## Brisbane Central Business District Bicycle User Group

The CBD Bicycle User Group (CBD BUG) is writing to you regarding the lack of progress on making the CityLink Cycleway lanes permanent and the current poor condition of these lanes.

Figure 6

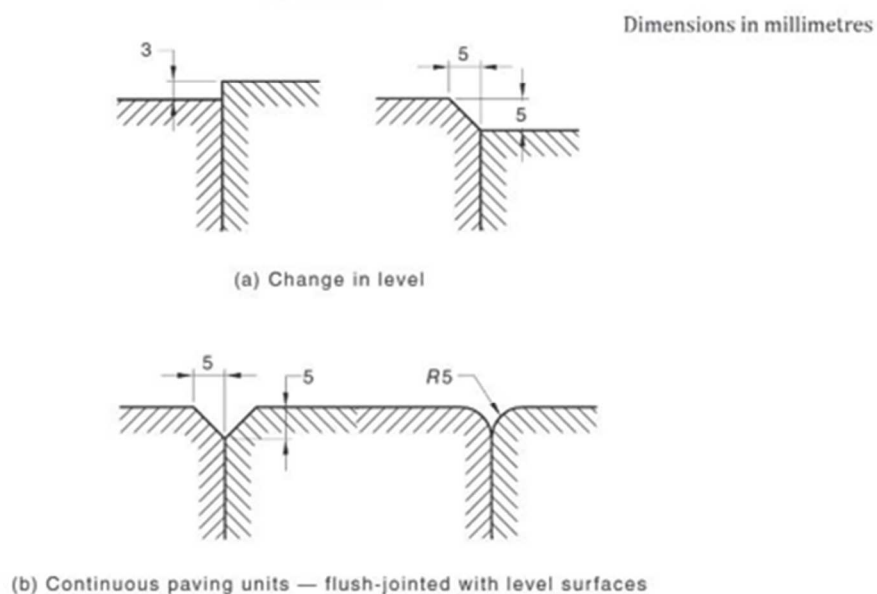
The most pressing of these from a safety perspective is the cycleway's crossing of Eagle St at Fig Tree Reserve. Even before the installation of CityLink this pedestrian crossing was at capacity and needed a reduction in the width of the road surface to be traversed, increases in the width of the kerb ramps and the installation of widened footpaths (on the reserve itself). These changes are necessary given that the current kerb ramps and surface material on the reserve side of this crossing appear to be non-compliant with the Australian Standard for disability access AS1428.1. (Figure 5,6&7).

Accordingly, the CBD BUG would like to enquire if there has been any design work to align this crossing with the above parameters and if/when these corrective works might occur?

Figure 8

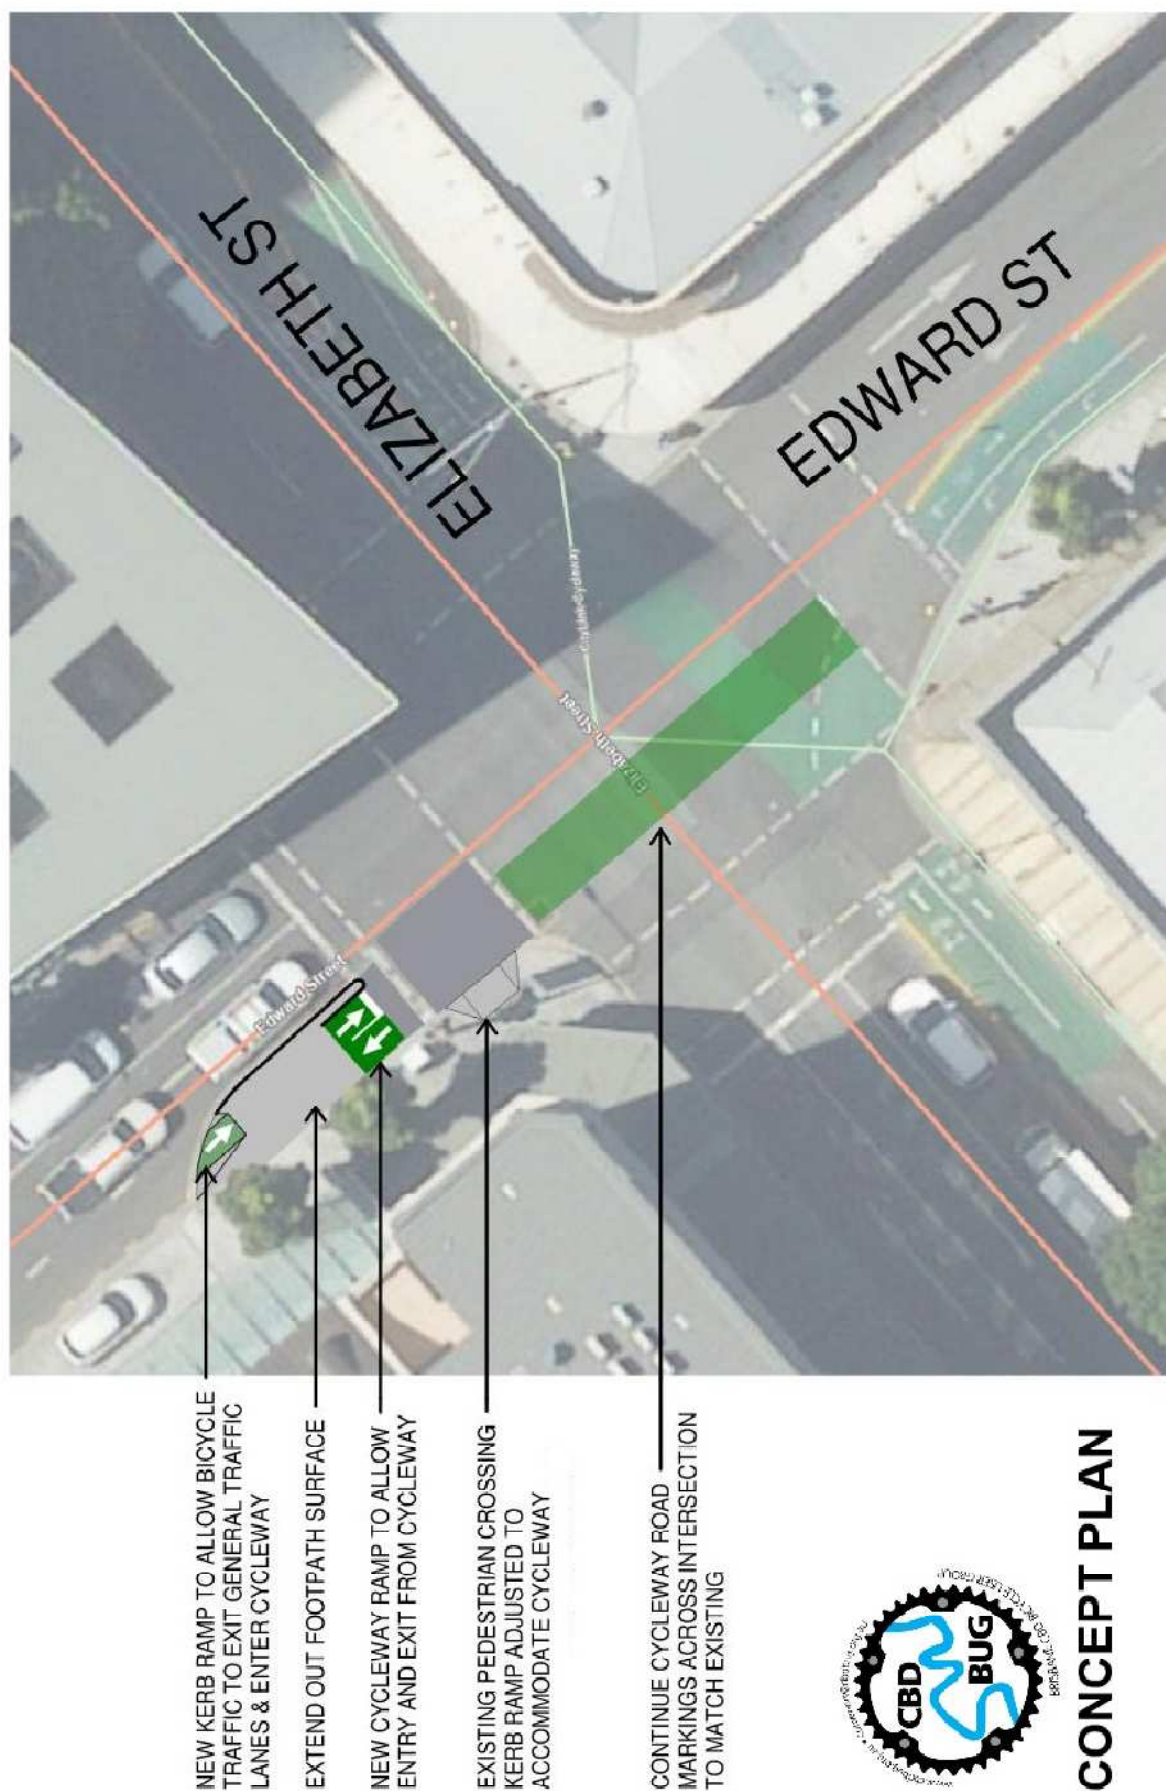
Accessing and egressing from the Edward St Cycleway lanes is dangerous. Riders exiting the lane and continuing along Edward St must merge into the pedestrian crossing. This creates a capacity issue due to high pedestrian numbers. Riders travelling along Edward St on road wishing to enter the Edward St cycleway lanes have no clear way to enter these lanes.

We ask that the lanes continue across the intersection, similar to Figure 8. This will result in a clearer and safer situation for all active transport users at this location.
